Entergy Nuclear Operations, Inc.
Palisades Nuclear Plant
27780 Blue Star Memorial Highway
Covert, MI 49043-9530
Tel 269 764 2000

SUBJECT: Response to Second Request for Additional Information Regarding the License Amendment Request to Implement 10 CFR 50.61a (TAC No. MF4528)

Palisades Nuclear Plant
Docket No. 50-255
Renewed Facility Operating License No. DPR-20

Response to Second Request for Additional Information Regarding the License Amendment Request to Implement 10 CFR 50.61a

Figure 4-1 Identification and Location of Beltline Region Materials for the Palisades Reactor Vessel ⁽³⁾

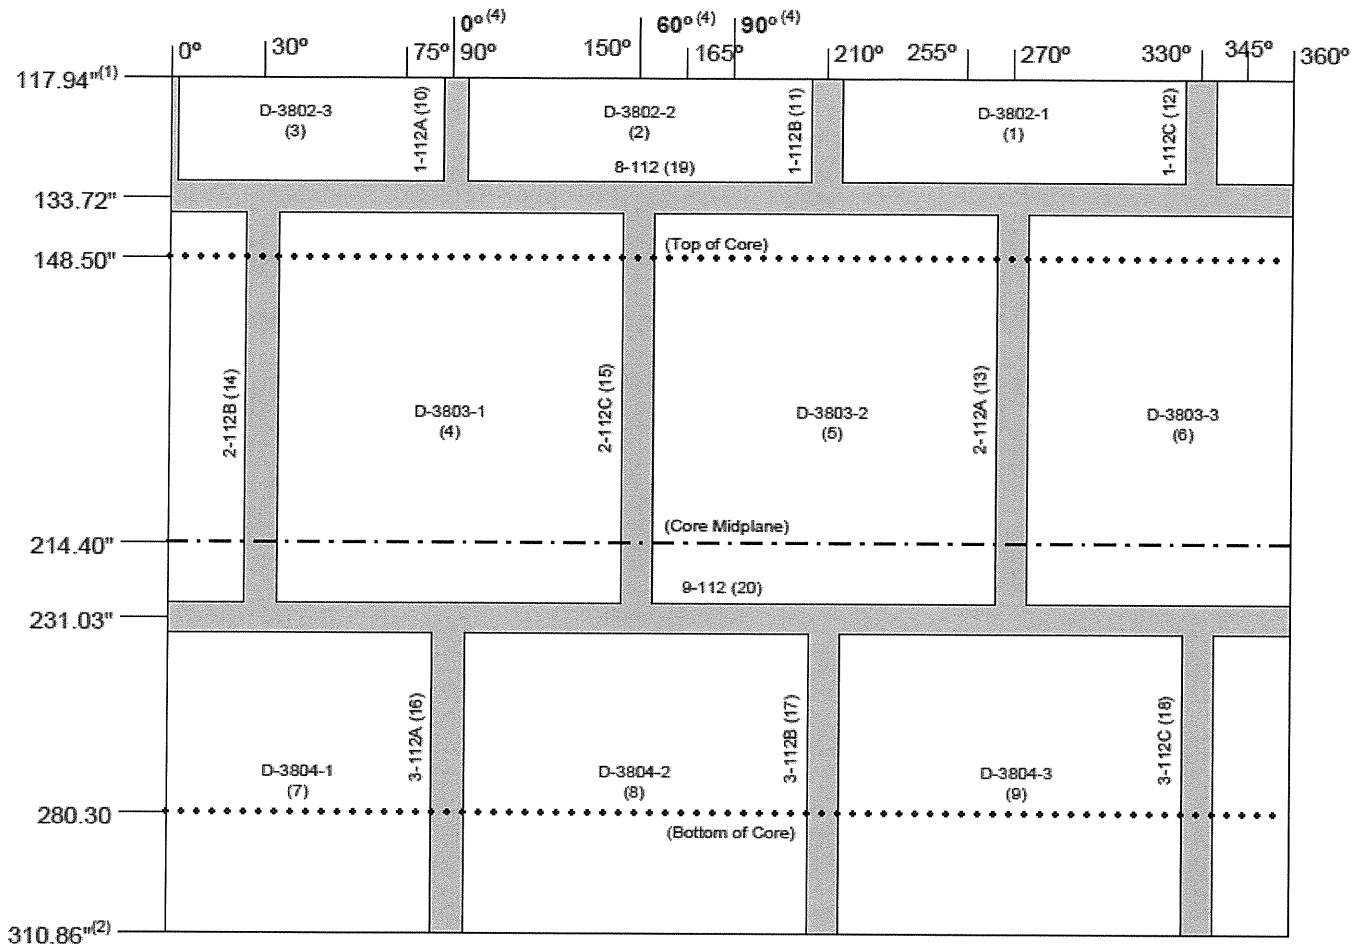
In reviewing the responses, the staff noted that the flux values in the response to RAI 2c match those for the 60° azimuth in Table 2.2-3 of WCAP-15353-Supplement 2-NP, Revision 0. In the revised Figure 4-1 there is no intermediate shell longitudinal weld at the 60° azimuth. With further staff review of the previously approved PTS evaluations from 2000 and 2010, including WCAP-15353, Revision 0, "Palisades Reactor Pressure Vessel Neutron Fluence Evaluation" dated January 2000 and WCAP-15353-NP, Revision 0, Supplement 1, "Palisades Reactor Pressure Vessel Fluence Evaluation" (ADAMS Accession Nos. ML003686582 and ML110060695, respectively), the staff notes that there is mention of the limiting intermediate shell longitudinal weld at the 60° azimuth, indicating that there was a change in the azimuthal coordinate system for the welds that was not

explicitly described. Based on the RAI responses dated February 13, 2015, and past PTS evaluations, the NRC staff requests further clarification on the responses to RAIs 2b and 2c related to the frame of reference for the azimuthal locations of peak fluence and the axial welds. The NRC staff requests that the change in the azimuthal coordinate system for the welds be provided (e.g. by an additional revision to Figure 4-1) to illustrate the azimuthal variation of projected fluence values after 42.1 EFPY of operation. The visualization of how the fluence varies by azimuthal position and how that fluence distribution compares with the location of the vessel shell longitudinal welds should provide an unambiguous representation of the extended beltline region (e.g. a visual display of the information from Table 8-1, “RT_{MAX-AW} Calculation Results for Palisades at 42.1 EFPY” in the LAR).

The azimuthal coordinate system shown in Figure 4-1 in the RAI response dated February 13, 2015 pertains to a reactor design azimuthal coordinate system which differs from the azimuthal coordinate system used in the fluence evaluation. The fluence evaluation used a quadrant model of the reactor to evaluate reactor neutron exposure, as shown in Figure 2.1-1, “Palisades r,θ Reactor Geometry,” of WCAP-15353-Supplement 2-NP, Revision 0. In this quadrant model of the reactor, the range of the azimuthal coordinate system extends from 0 degrees to 90 degrees, and is offset from the reactor design coordinate system by 90 degrees. For example, longitudinal welds 1-112A and 3-112A shown at 90 degrees in Figure 4-1, which depicts the reactor design azimuthal coordinate system, are oriented at 0 degrees in the fluence evaluation azimuthal coordinate system, and longitudinal weld 2-112C, which is shown at 150 degrees in Figure 4-1, is located at 60 degrees in the fluence evaluation azimuthal coordinate system.

A revised Figure 4-1 is provided below to clarify the location of reactor vessel materials within the azimuthal coordinate system used in the reactor quadrant model in the fluence evaluation. In this revised figure, the azimuthal coordinate system used in the fluence evaluation is shown in bold, as described in Note 4 in the figure.

Table 8-1, “RT_{MAX-AW} Calculation Results for Palisades at 42.1 EFPY,” in WCAP-17628-NP, Revision 1, “Alternate Pressurized Thermal Shock (PTS) Rule Evaluation for Palisades,” dated June 2014, provides calculated RT_{MAX-AW} values for the reactor vessel beltline and extended beltline welds. In this table, the maximum fluence calculated for any of the upper shell longitudinal welds, $0.09707 \times 10^{19} \text{ n/cm}^2$, was applied to all of the upper shell longitudinal welds. Likewise, the maximum fluence calculated for any of the intermediate and lower shell longitudinal welds, $2.161 \times 10^{19} \text{ n/cm}^2$, was applied to all of the intermediate and lower shell longitudinal welds. The maximum fluence for all longitudinal welds occurs at 60 degrees in the fluence evaluation azimuthal coordinate system.
